DEPARTMENT OF THE AIR FORCE
AIR FORCE BASE CONVERSION AGENCY

SUBJECT: Submittal - Primary Document - Final Supplemental Investigations Report

Final Response to Comments Draft Report for Supplemental Investigations of Areas of Concern Griffiss Air Force Base Submitted November 1997

Comments on Draft SI Report sections by Dean Williams, U.S. Army Corps of Engineers, Kansas City District, Dated November 1997.

Figure 4.11.4.10-1
SUPPLEMENTAL INVESTIGATION
SAMPLE LOCATION AND
GROUNDWATER CONTOUR MAP
LANDFILL 6

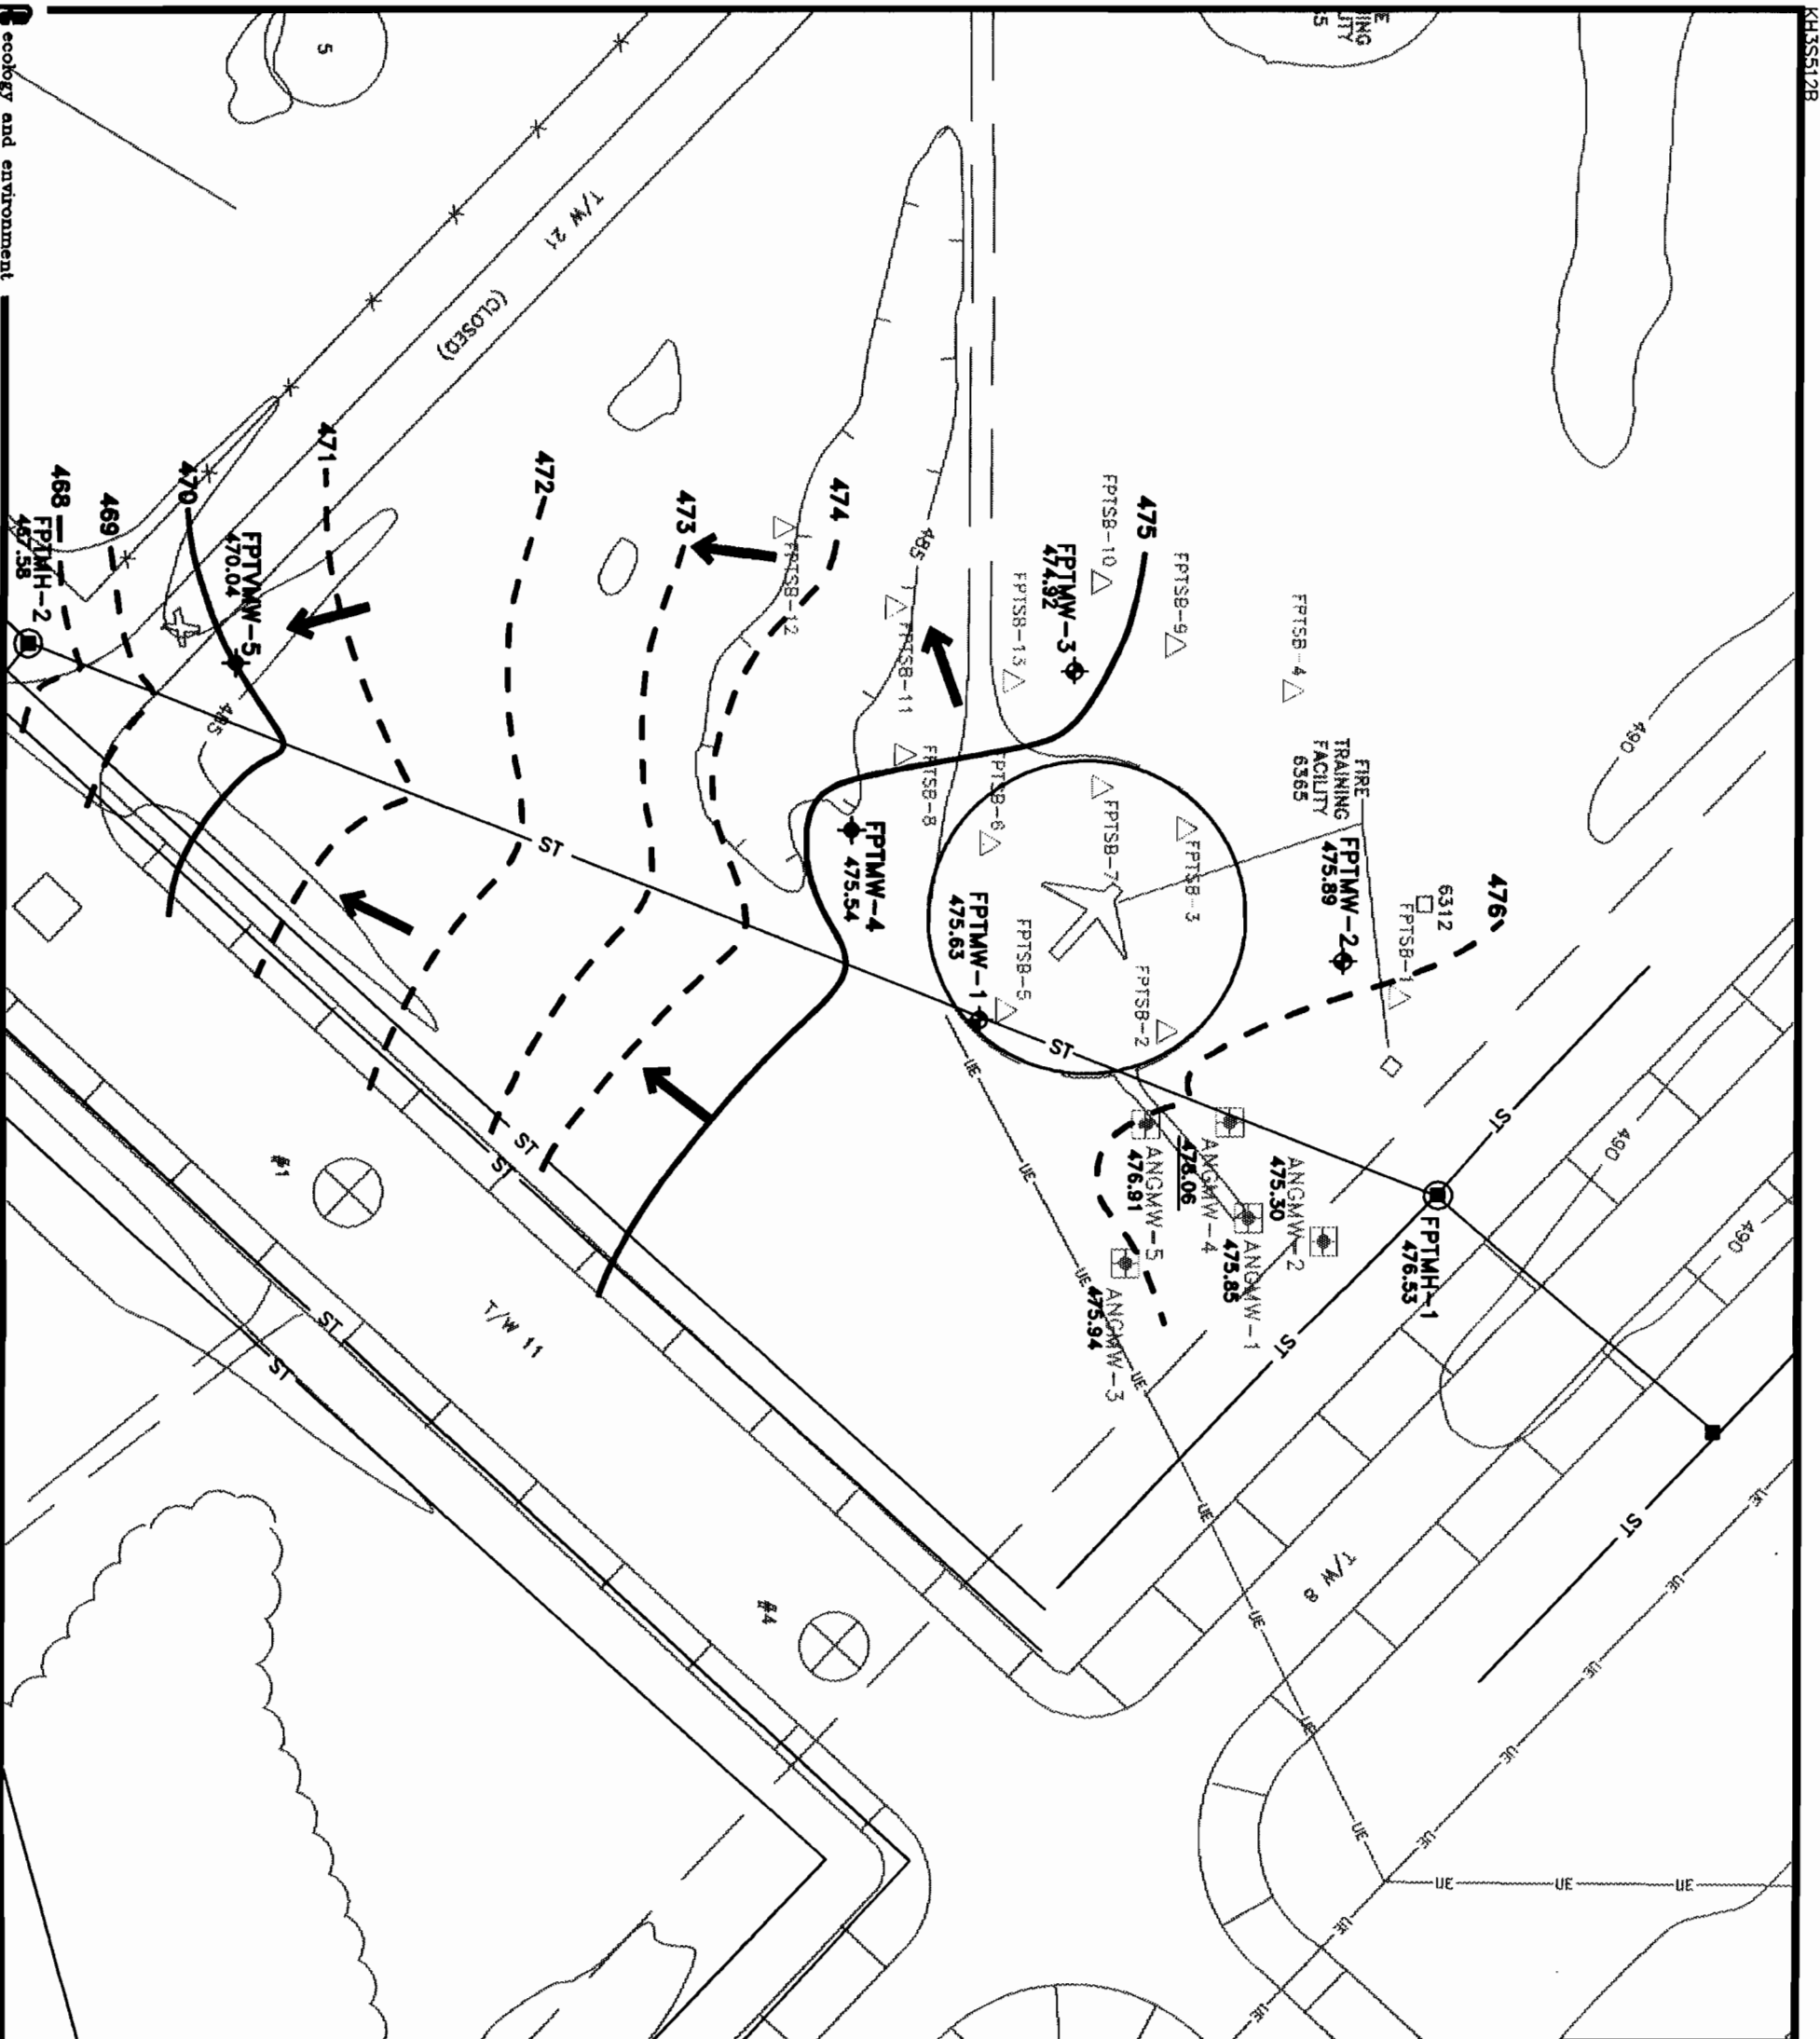
In addition, the direction of groundwater flow, identified on Figure 4.11.4.10-1, is different from the flow presented in the RI. A discussion should be provided in the text that explains why the direction of groundwater flow is different than previously thought.

Figure 4.11.4.11-2: Added 775VMW-9 and 775VMW-10.

Figure 4.11.4.12-1
SUPPLEMENTAL INVESTIGATION
SAMPLE LOCATION AND
GROUNDWATER CONTOUR MAP
FIRE PROTECTION TRAINING AREA

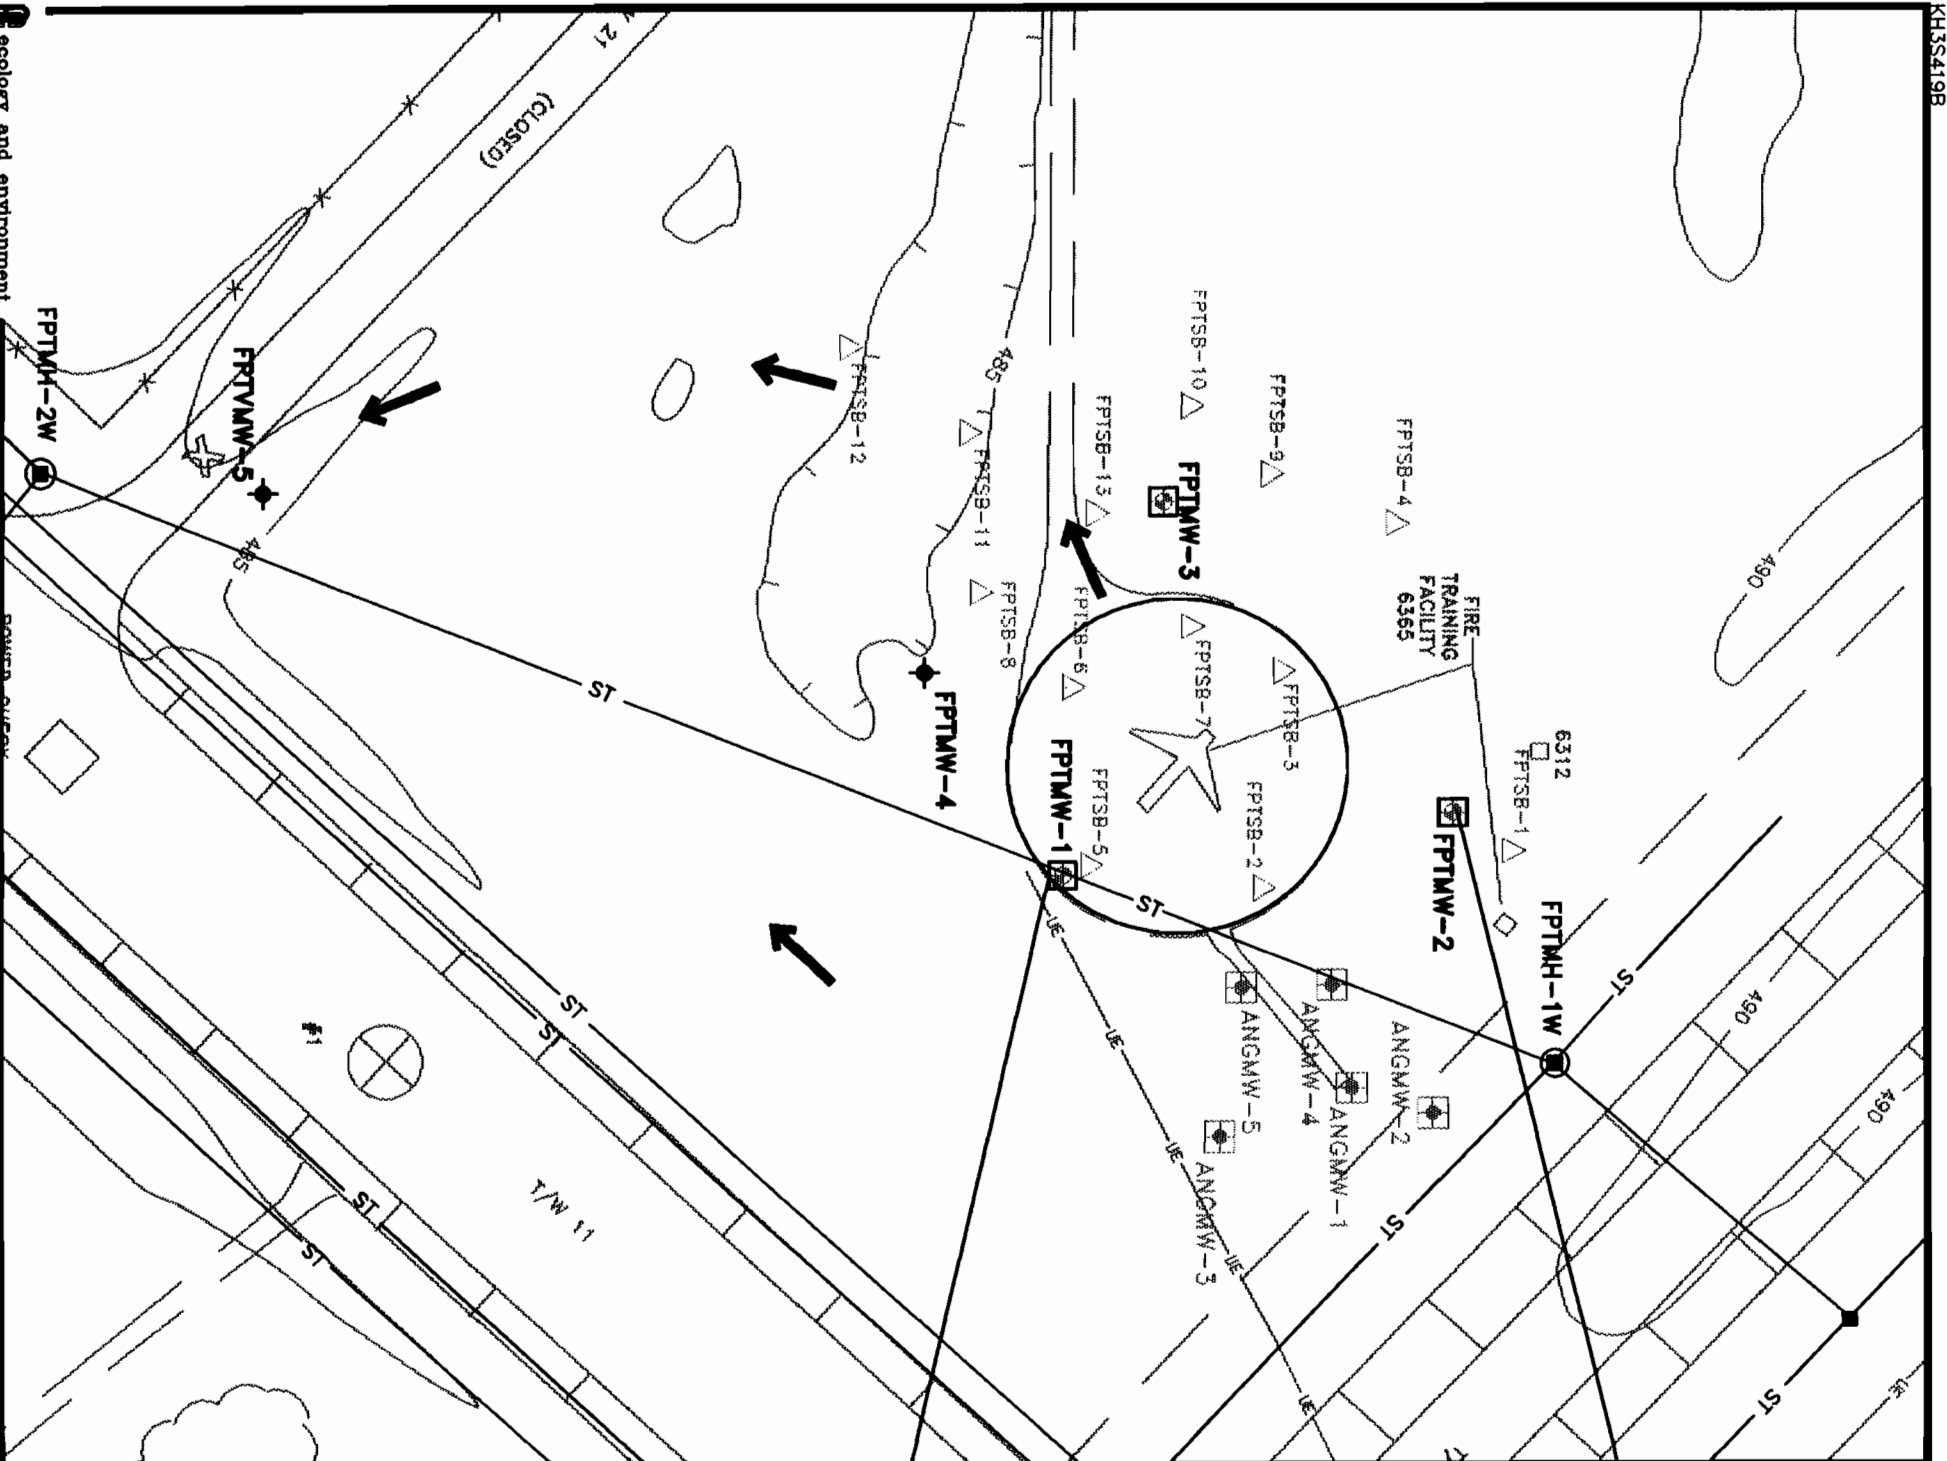
Figure 4.11.4.12-1: Underlined groundwater elevation at ANGMW-4 and added note to legend.
